District	County	Resolution Number	Resolution Type	Section Number
3	DeKalb	2023-049	Supplemental	23-00000-00-GM

ADDENDUM NO. 1

**CITY OF DEKALB
Streets 2023
Quest eBidDoc # 8376450
DeKalb, IL
March 23, 2023**

SHEET NUMBER:
21 of 61

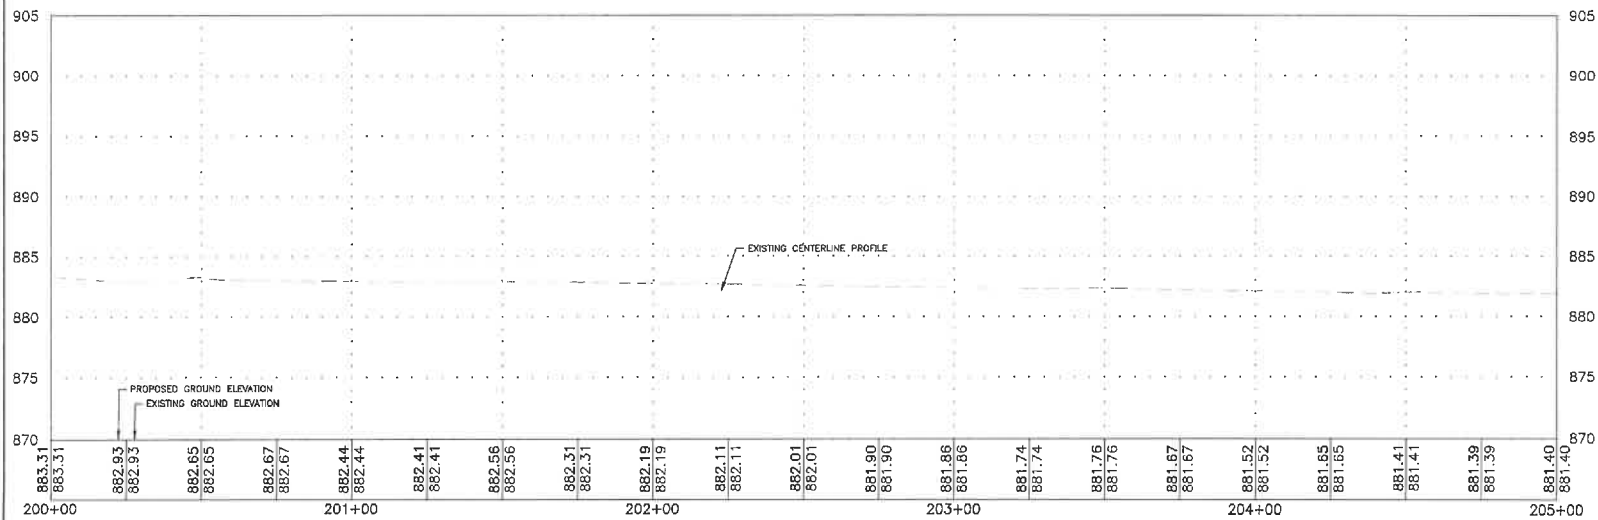
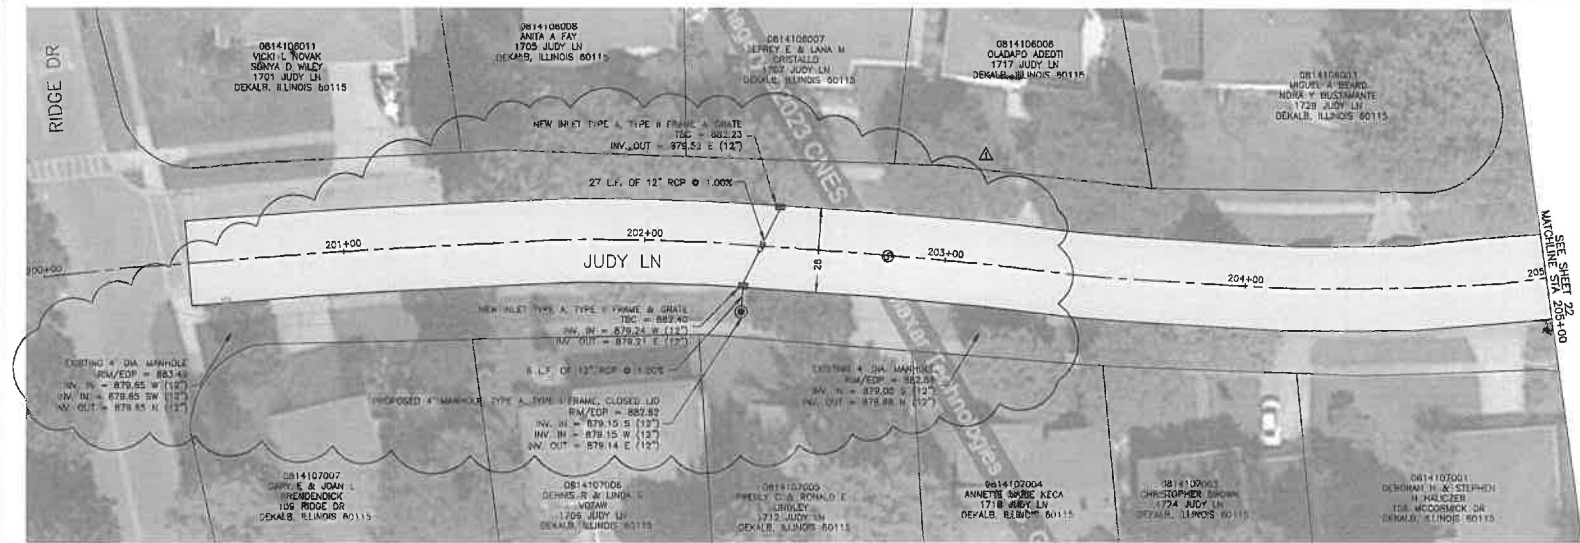
1. The following Plan Set pages have been modified to reflect the updated pay items above and are a part of the bid documents and attached to this Addendum No. 1. Please refer to and use the attached Plan Set pages when preparing and submitting your bid.
 - a. Page 11 of 61 has been modified to reflect the updated pay items above.
 - b. Page 21 of 61 has been modified to reflect the updated pay items above.
